**CITY COUNCIL AGENDA  
MONDAY, JUNE 15, 2020  
250 NORTH 5<sup>TH</sup> STREET  
6:00 PM – SPECIAL MEETING – CITY HALL AUDITORIUM**

Item #1.a.i.

A Resolution Accepting the Petition for Annexation of 45.543-Acres of Land and Ordinances Annexing and Zoning the Magnus Court Annexation to PD (Planned Development) for Two (2) Properties and An Ordinance Rezoning Two (2) Properties from R-E (Residential Estate) and R-2 (Residential – 2 Dwelling Units Per Acre) to PD (Planned Development) with an Outline Development Plan Called Magnus Court to Develop 74 Single-Family Detached Lots with an R-2 (Residential – 2 du/ac) Default Zone District. The Properties Combined are 69.67 Acres and are Generally Located at the West End of Magnus Court and Include the Property Addressed as 2215 Magnus Court #A - [Staff Presentation](#) and [Applicant Presentation](#)

Figure 15: Design Year Total Traffic (2040) (35% NB, 65% SB)

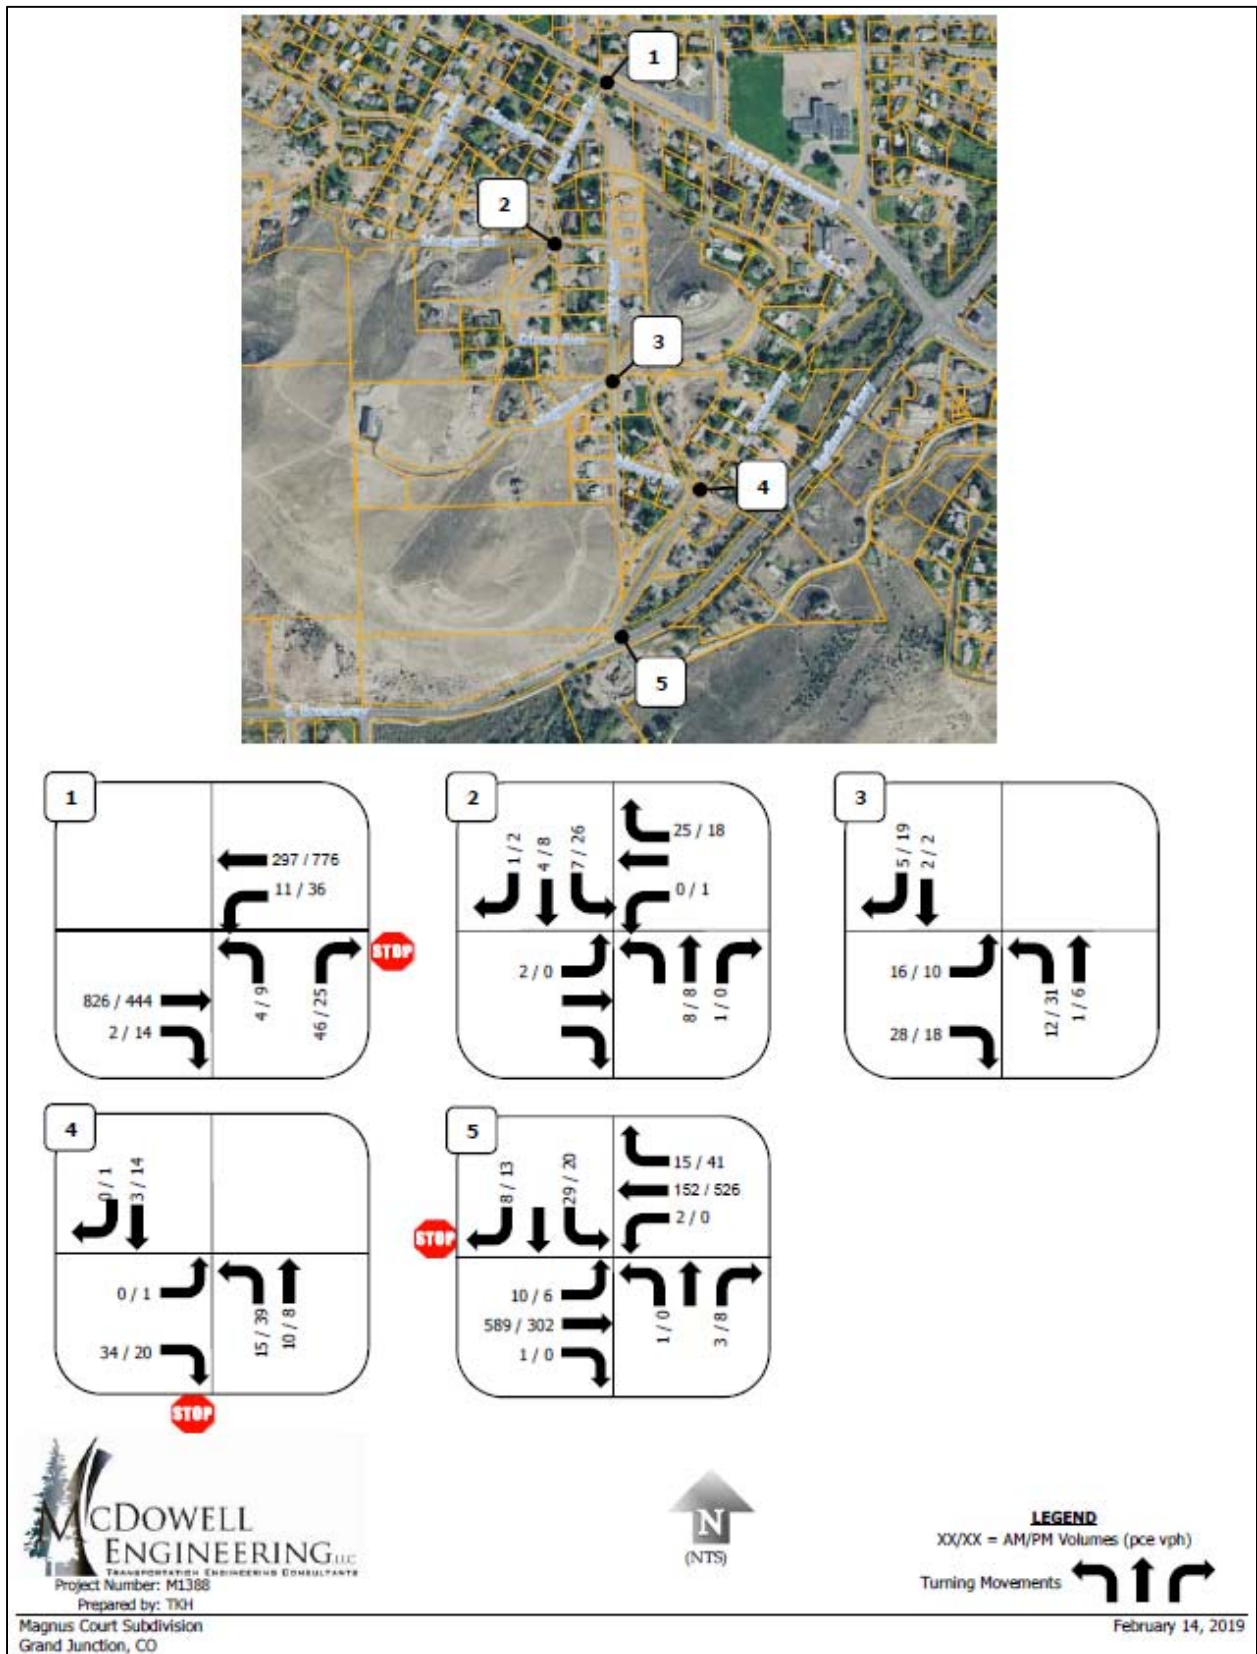
3. It appears that the numbers used in the 2040 BG AM analysis don't match those shown in Figure 15. **The numbers used in the 2040 BG AM analysis should be from Figure 6.**

**Figure 7A: AM Project Traffic Distribution (15% NB, 85% SB)**

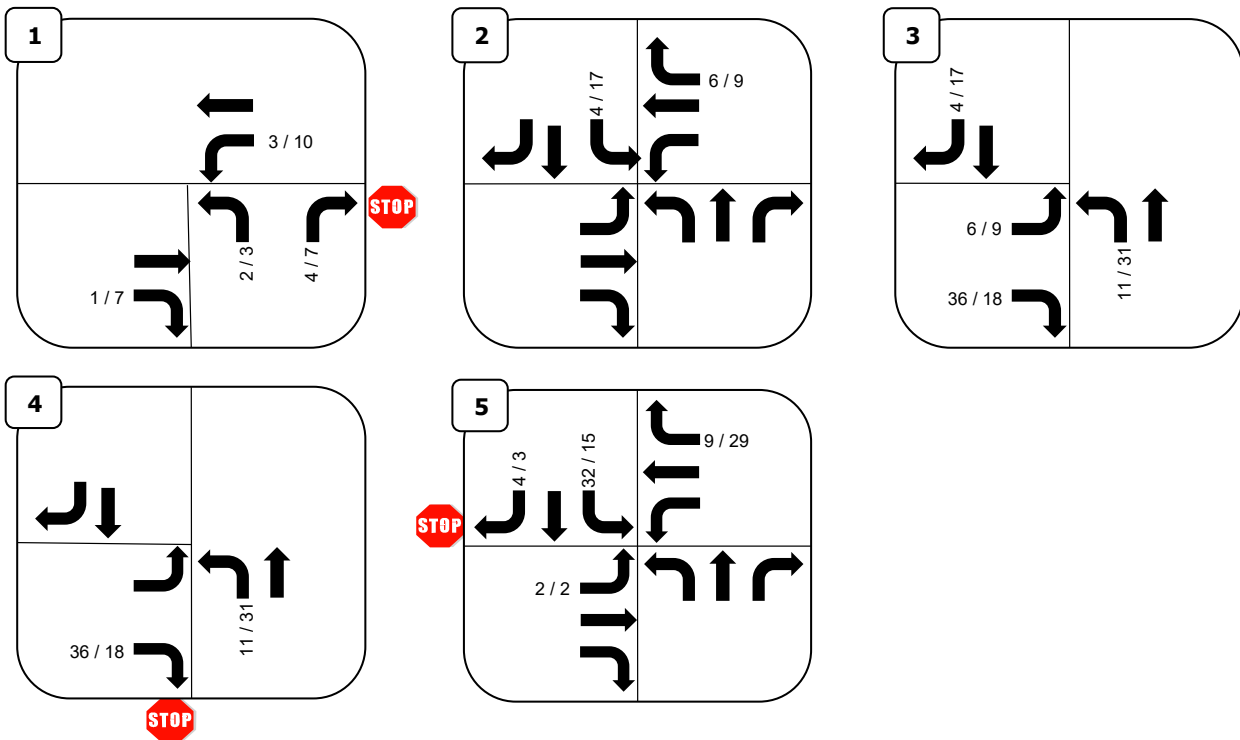
A new scenario was analyzed with northbound traffic reduced to 15% during the morning peak hour. The resultant trip distribution percentages and site-generated traffic volumes are shown in Figure 7A and Figure 9A, respectively. When the site-generated traffic is added to the initial background volumes from Figure 5 in the TIS, the initial year total traffic is shown in Figure 13A. When the site-generated traffic is added to the design year background volumes from Figure 6 in the TIS, the design year total traffic is shown in Figure 15A.
